World Forum for Harmonization of Vehicle Regulations

Proposal Supplement 2 to the 03 series of amendments to UN Regulation No. 94 (Frontal collision)

Submitted by the Working Party on Passive Safety *

Figure 4

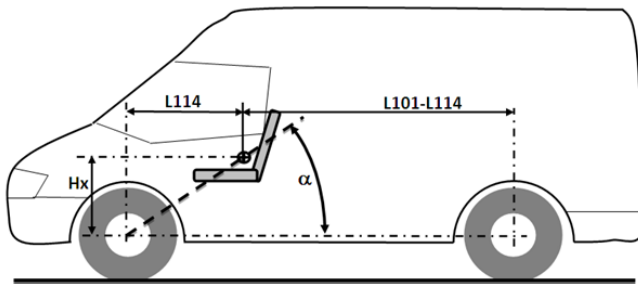
- 5.3.2. Vehicles of category N₁ of a total permissible mass exceeding 2,250 kg but not exceeding 2,500 kg are deemed to meet the requirements of paragraph 5, where their structural basis is a ladder frame and the requirements of UN Regulation No. 137 are fully complied with and at least one of the following conditions is met:
- (a) The acute angle alpha (α), measured between a horizontal plane passing through the centre of the front axle and an angular transverse plane

passing through the centre of the front axle and the R-point of the driver's seat (see Figure 4 below), is more than 22°;

- (b) Or the ratio between the distance from the driver's R-point to the centre of the rear axle (L101-L114) and the centre of the front axle and the driver's R-point (L114) is more than 1.30 (see Figure 4 below).
